November 6, 2017

SUBJECT: NuScale Power, LLC Submittal of Changes to Final Safety Analysis Report, Tier 1, Chapter 5

Enclosure: "Changes to NuScale Final Safety Analysis Report, Tier 1, Chapter 5"

Figure 5.0-1: NuScale Horizontal Certified Seismic Design Response Spectra 5% Damping

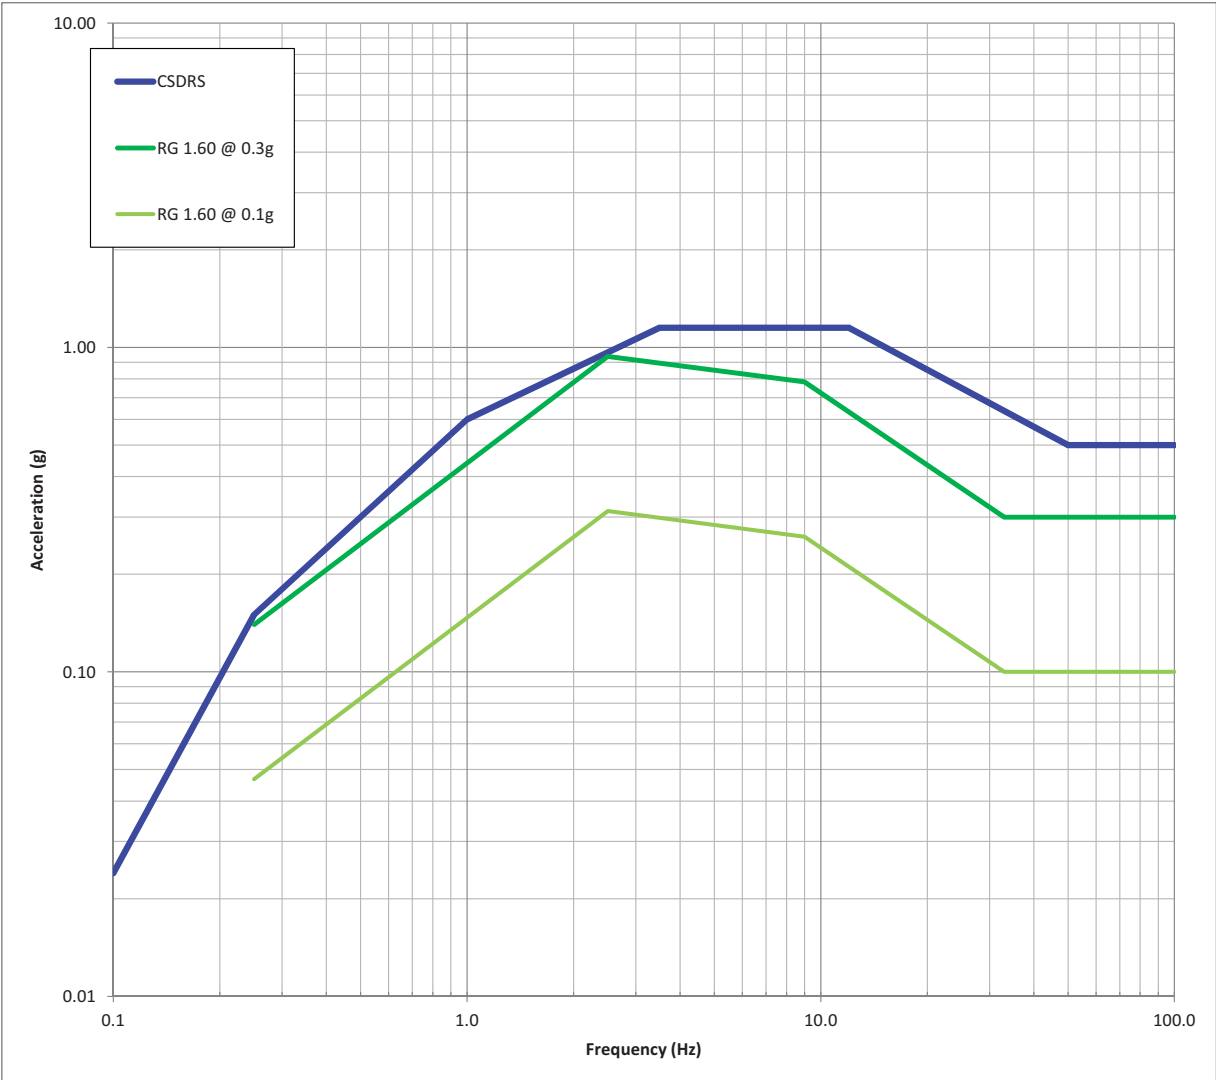
NUScale has determined that Final Safety Analysis Report (FSAR), Tier 1, Chapter 5 Figures 5.0-1 and 5.0-2 were inconsistent with Figures 3.7.1-1 and 3.7.1-2 of FSAR, Tier 2, Section 3.7.1. The Enclosure to this letter provides a mark-up of the FSAR pages incorporating revisions to Chapter 5 to correct this inconsistency. NuScale will include this change as part of a future revision to the NuScale Design Certification Application.
